METROPOLITAN GOVERNMENT OF NASHVILLE AND DAVIDSON COUNTY

STAFF RECOMMENDATION
1406 Holly Street
February 19, 2014

Application: New construction—Amend previously approved design for an infill;
Demolition—outbuilding
District: Lockeland Springs-East End Neighborhood Conservation Zoning Overlay
Council District: 06
Map and Parcel Number: 08309044000
Applicant: John Root, rootARCH
Project Lead: Melissa Baldock, melissa.baldock@nashville.gov

<p>Description of Project: Applicant proposes to amend the design for infill approved by the Commission in April 2013, and to demolish an existing outbuilding.</p>	<p>Attachments A: Photographs B: Site Plan C: Elevations</p>
<p>Recommendation Summary: Staff recommends approval of the infill’s redesign and the demolition of the outbuilding with the following conditions:</p> <ol style="list-style-type: none">1. The width of the structure be reduced at the front to a maximum of thirty-four (34’) feet for a depth of at least twenty feet (20’);2. The applicant submit revised drawings reconciling the window pattern on the floor plans and elevations.	
<p>With these conditions, staff finds that the project meets the design guidelines II.B. for new constr

A1 FIRST FLOOR PLAN

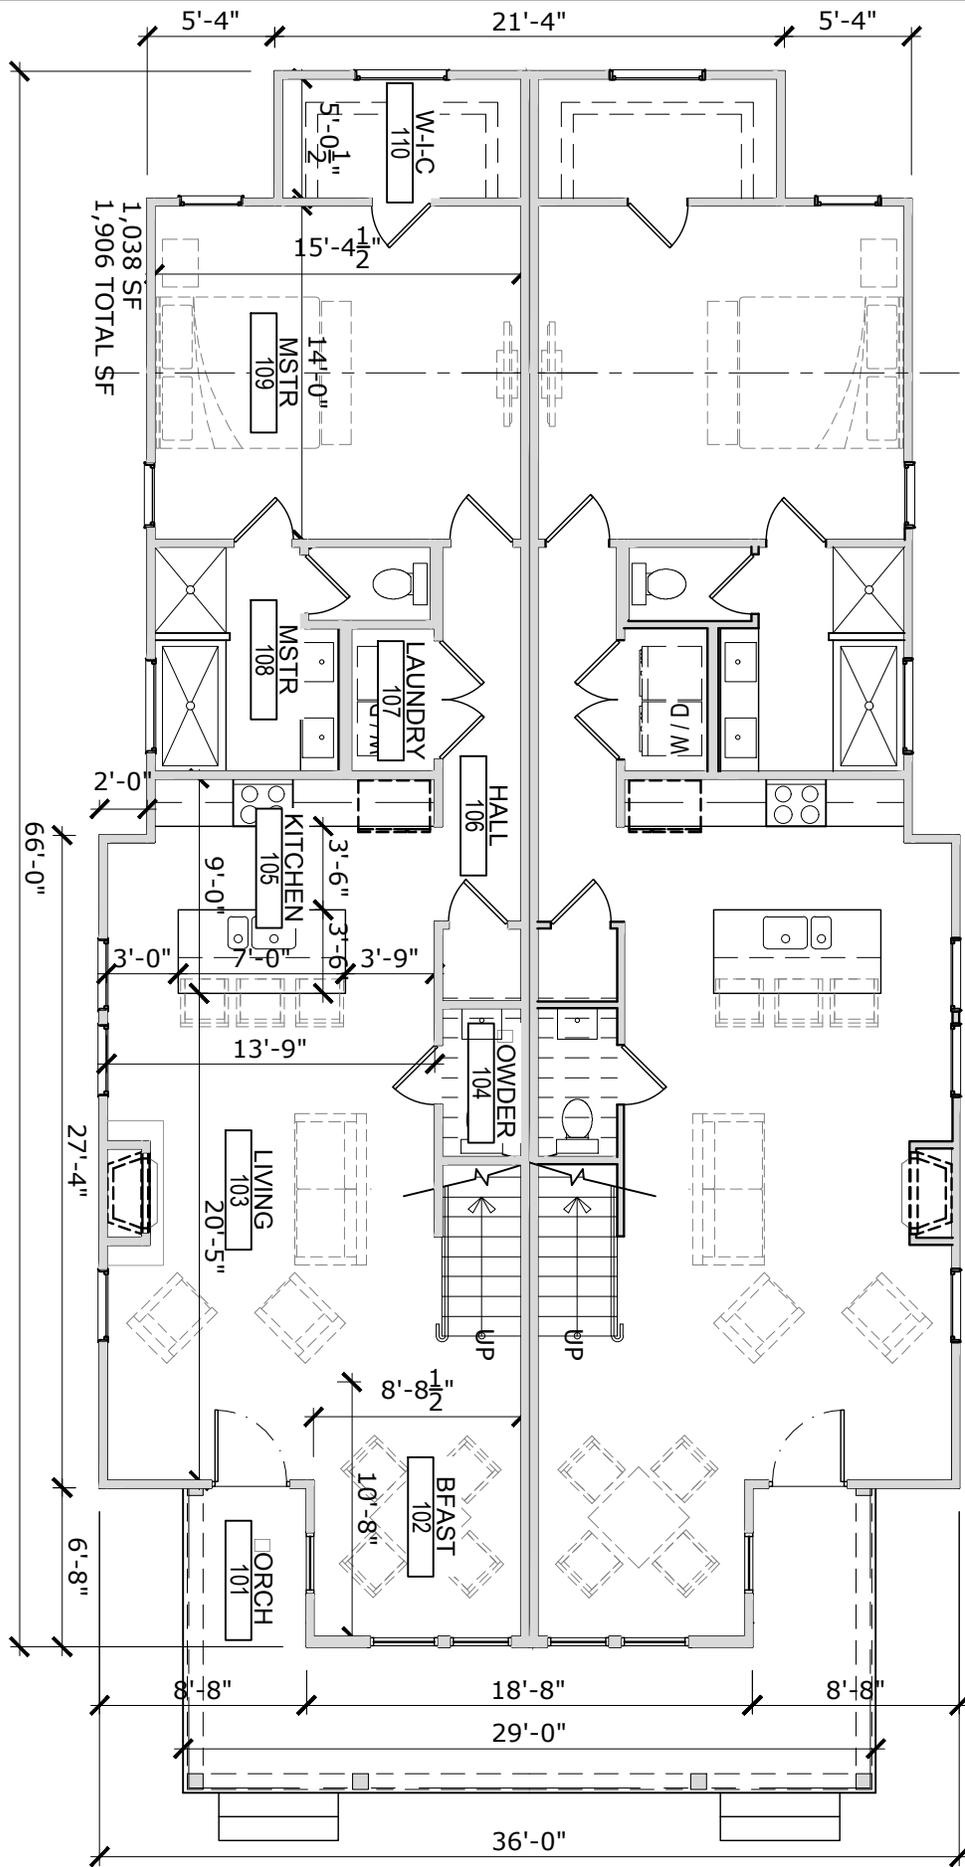
The width of the previous and the revised varies at different points in the design. The revised width is primarily thirty-six feet (36') wide; by comparison, the widths of neighboring historic buildings vary between twenty five and thirty three feet (25'-33'). Staff finds that the width of the revised infill does not meet the historic context, and staff asks that the house be reduced in width so that it no more than thirty-four feet (34') wide at the front for at least a depth of twenty feet (20').

1. The width of the structure be reduced at the front to a maximum of thirty-four (34') feet for a depth of at least twenty feet (20');
2. The applicant submit revised drawings reconciling the window pattern on the floor plans and elevations.

A2 SECOND FLOOR PLAN

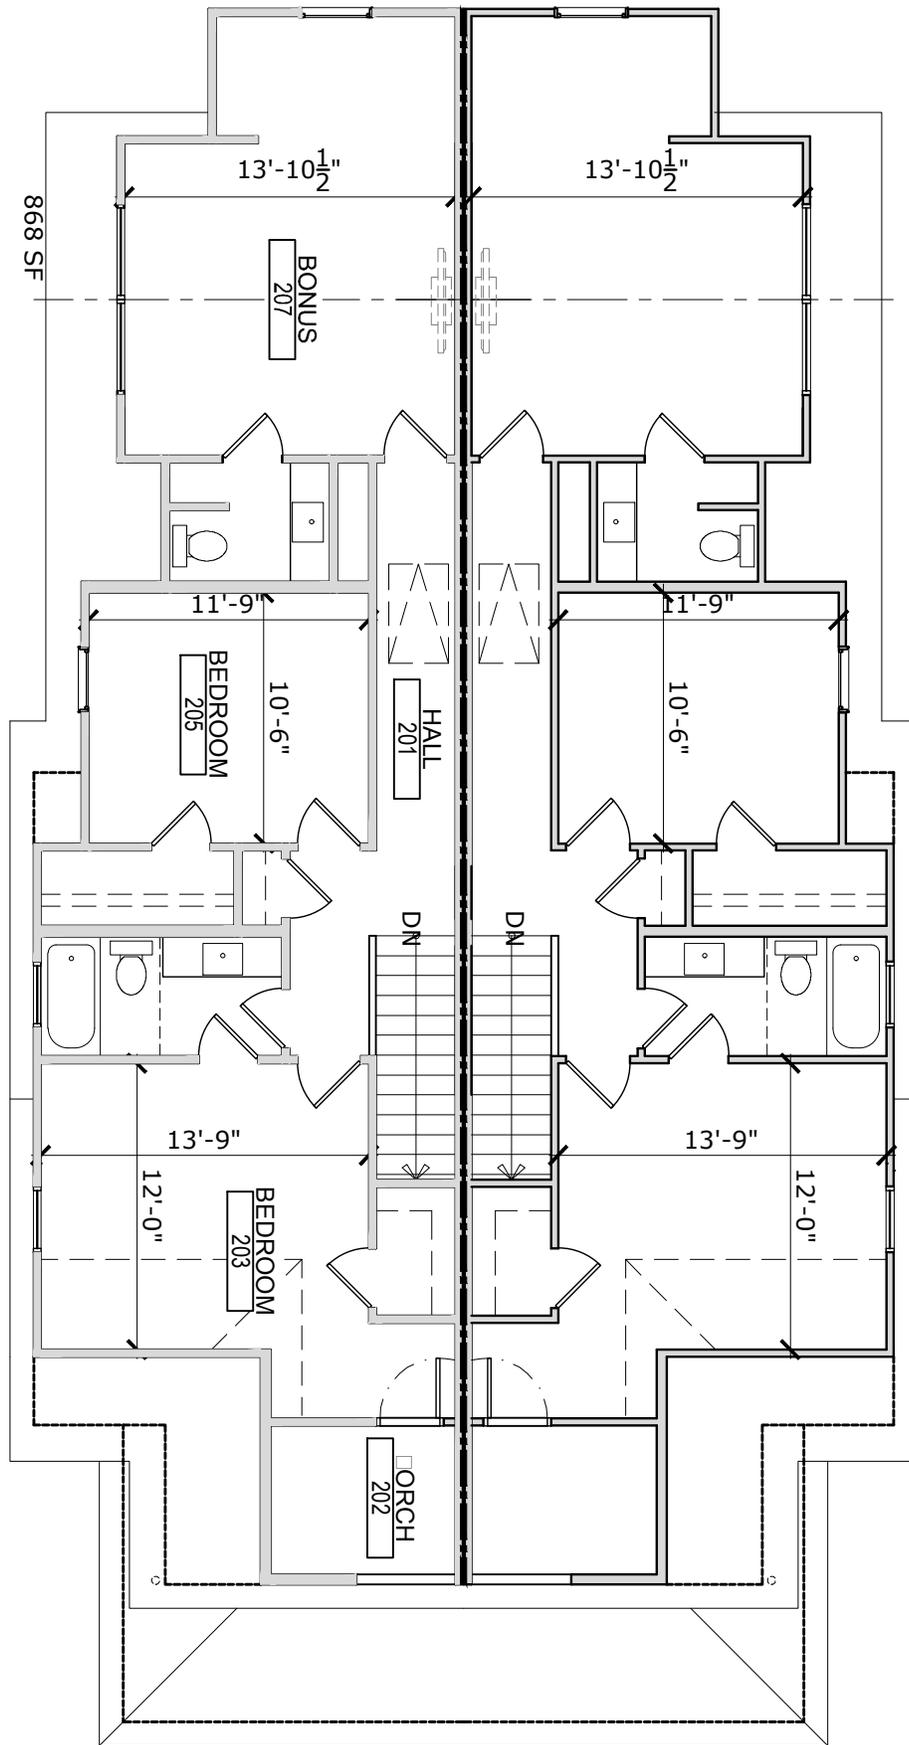
Proportion and Rhythm of Openings: The fenestration pattern of the infill has not significantly changed in the redesign. The primary windows are twice as tall as they are wide. There are no large expanses of wall space without a door or window opening. Staff notes that the second story floor plan shows two windows in the side gables, but the elevation just shows one window. Staff asks that the drawings be corrected prior to issuance of the permit. Paired windows have the minimum four inch (4") mullion required by the Commission on past projects. Staff finds that the infill meets section II.B.7. of the design guidelines.

EL1 FRONT ELEVATION

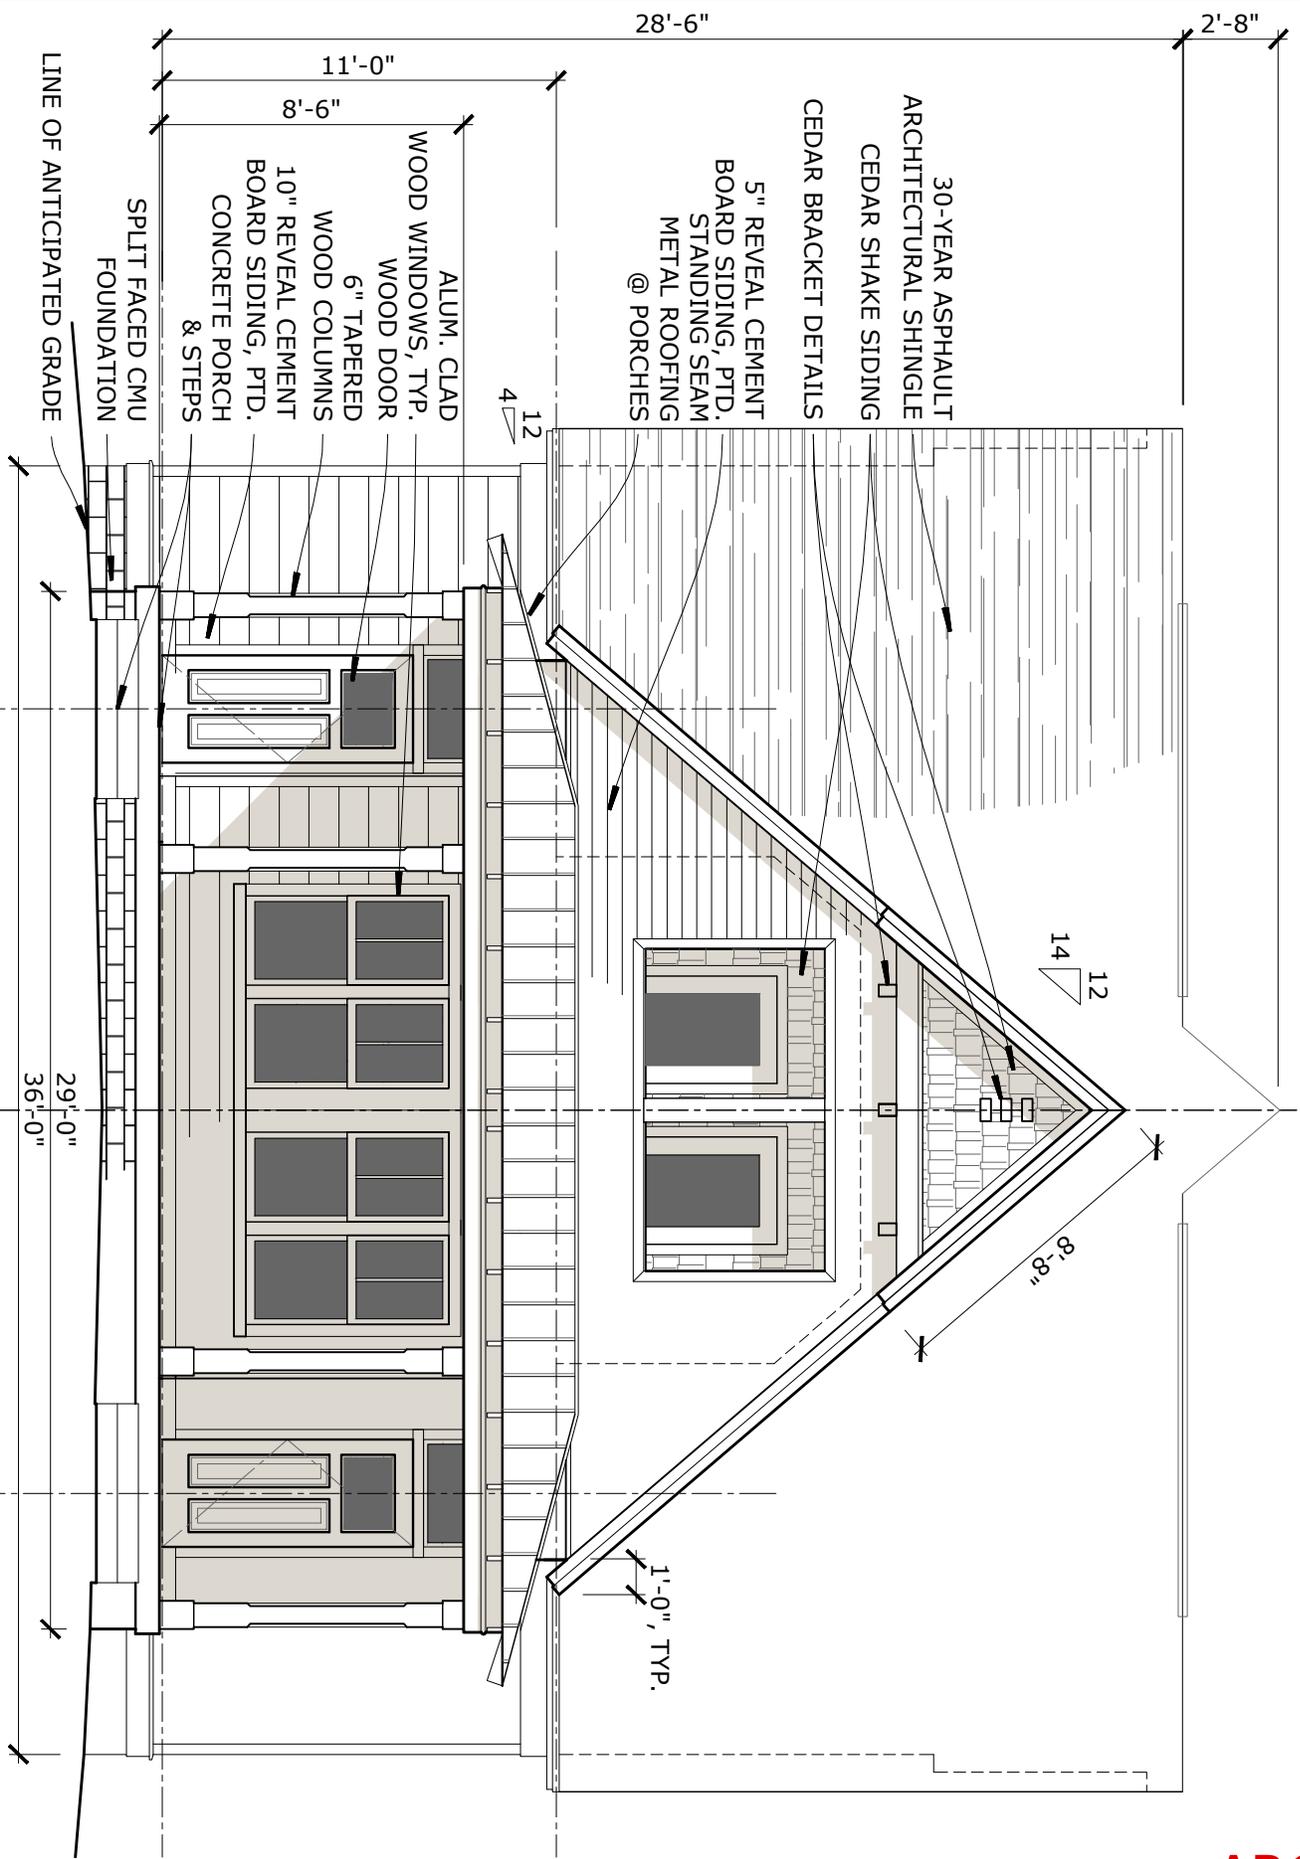
Height & Scale: The infill that the Commission approved in April 2013 was one-and-a-half stories in height. The revised drawings show no change in the eave and foundation heights. The ridge height will be six inches (6") taller than what was previously approved, for a total height of twenty-eight feet, six inches (28'6") and a six foot (6') wide peak that is two feet, eight inches (2'8") taller than the primary ridge. Staff finds the slight increase in height of the structure to match the historic context along Holly

Orientation: The previous design had one primary entrance oriented to the street. The new design has two-entrances with a wrap-around porch and two walkways oriented to the street. The porch has a minimum depth of six feet (6') and a maximum depth of thirteen feet (13'). Staff finds that the revised infill meets section II.B.6. of the design guidelines.

EL2 (TYPICAL) SIDE ELEVATION

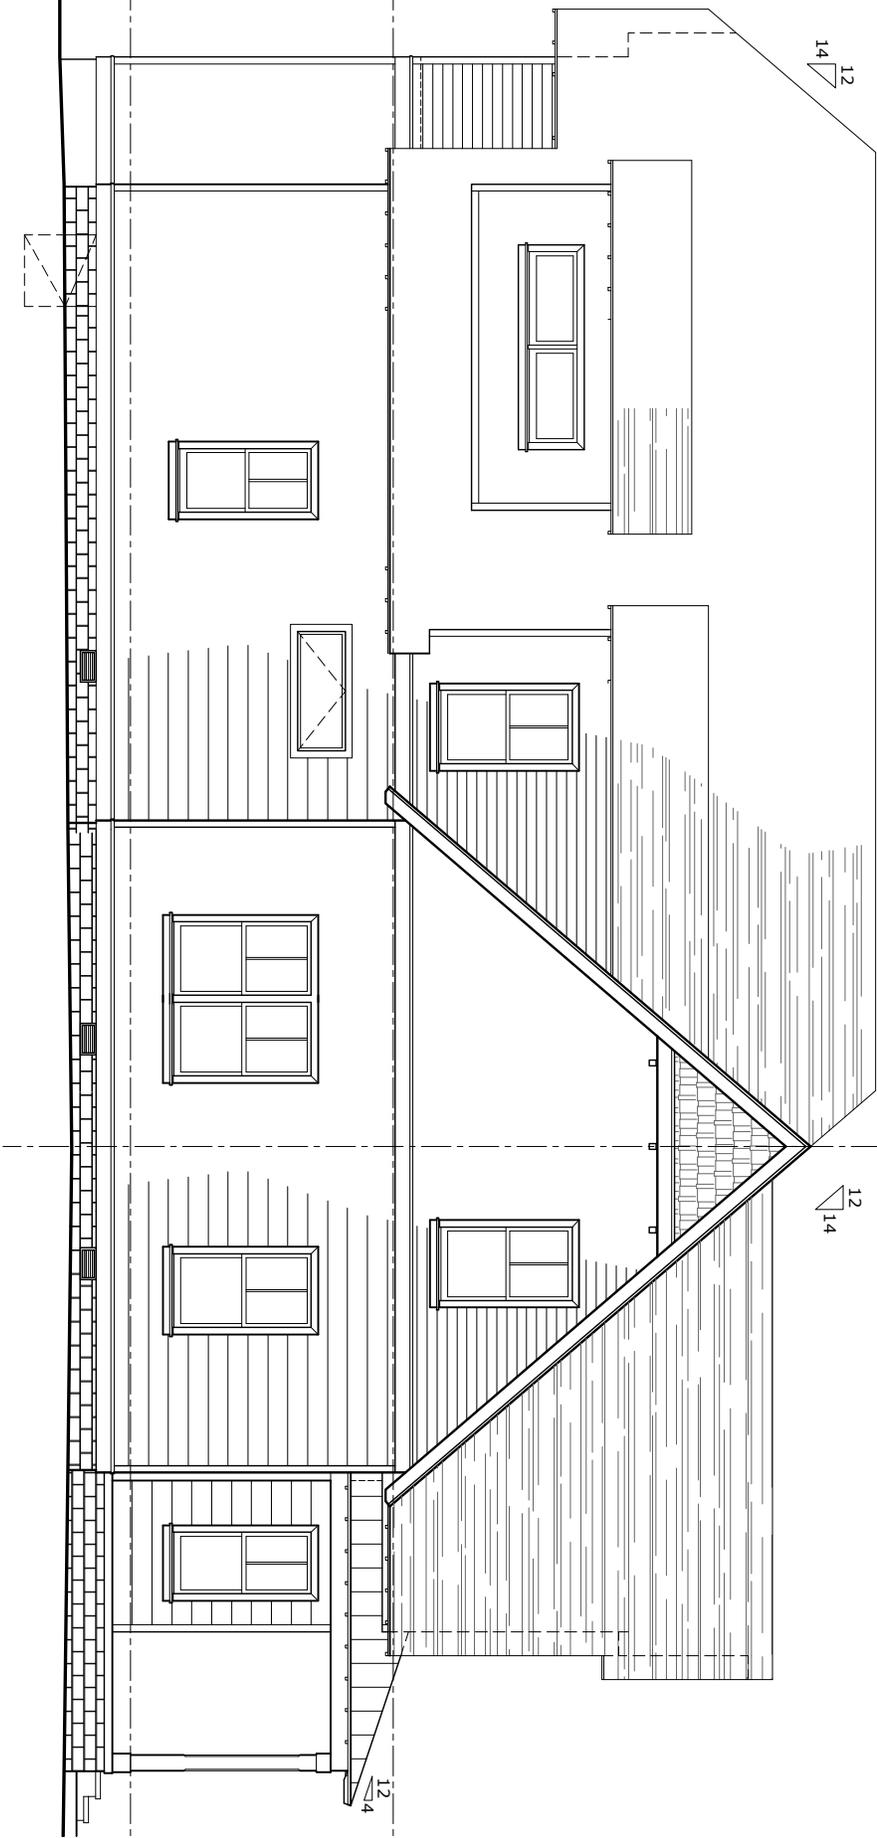
Roof Shape: The roof form of the redesigned infill is not significantly different than what was previously approved for the site. It is a cross-gable with slopes of 14/12, which matches other roofs in the district. Beyond the side gables, there is a wall-dormer type section that is inset two feet (2') from the side gable. While wall dormers are generally

not approved, staff finds this one to be appropriate because it is forty feet (40') behind the front porch, and is inset from the side gable portion of the house. It will likely not be visible. Also on the side facades are shed dormers that are set back two feet (2') from the wall below. Staff finds the roof shape to be appropriate and meets section II.B.5 of the design guidelines.
